## Erratum

"Lead-Acid Battery: Positive Grid Design Principles," B.S.T.J., Vol. 49, No. 7, September 1970, pp. 1279-1303, by A. G. Cannone, D. O. Feder and R. V. Biagetti.

Fig. 14—Rate constant ( $k$ ) on log scale vs  $1/T$  ( $^{\circ}\text{K}$ ) for  $5\text{-}5/8'' \times 5\text{-}7/8'' \times 1/4''$  thick PbSb grids.

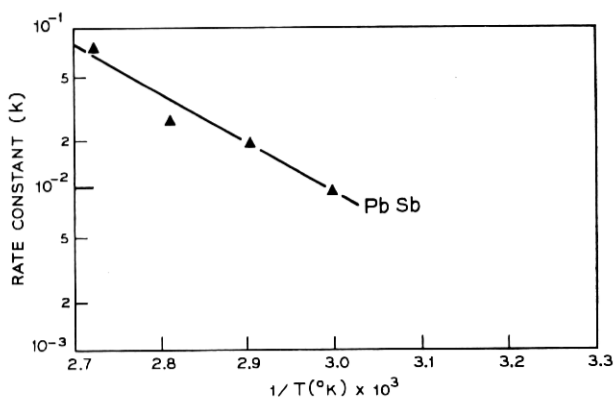
The log scale shown on Fig. 14 (p. 1291) for the rate constant ( $k$ ) is in error by a factor of ten. It should be:

This is a plotting error only and does not alter the data nor the conclusions shown.
